# Port Wallace Master Plan

# PPC UPDATE

#### CONCEPT PLAN

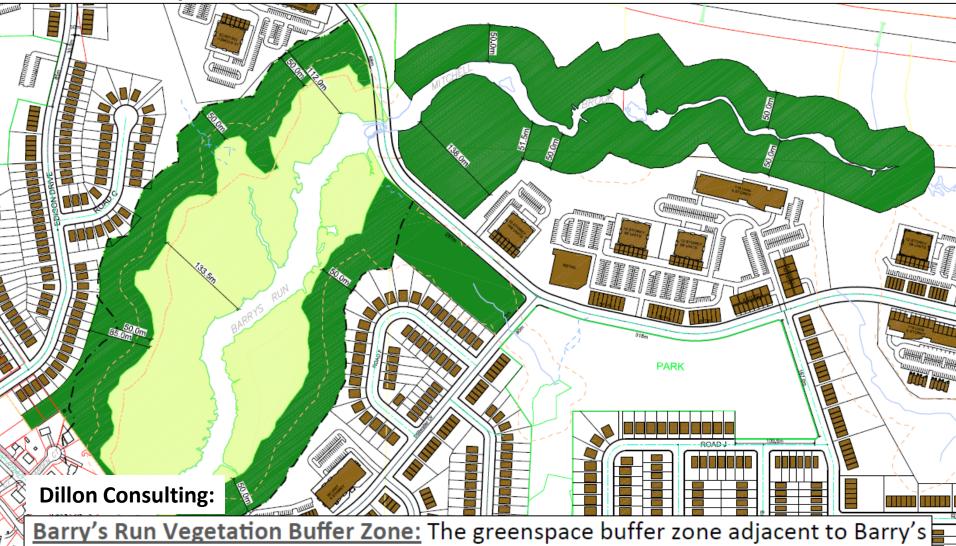
- 1. Protect Barry's Run / Mitchell Brook
- 2. Street oriented commercial.
- 3. Ave. Du Portage needs to be pedestrian friendly with animated / active street frontage.
- 4. Bring multiple residential buildings to the streetline.
- 5. Need improved parkland:
  - 1. Active Recreation (open play area, tennis courts, Playground)
  - 2. Leisure area (... "a nice place to read a book")
  - 3. Social Gathering Place
- 6. Improved road pattern (grid)

<u>Barry's Run Vegetation Buffer Zone:</u> The greenspace buffer zone adjacent to Barry's Run, providing further sedimentation and velocity controls for surface water runoff, will remain undisturbed. We recommend the proposed vegetative buffer width be increased from the typical minimum 20 m offset, to 50 m along Barry's Run; we understand this is now integrated into the development plan.
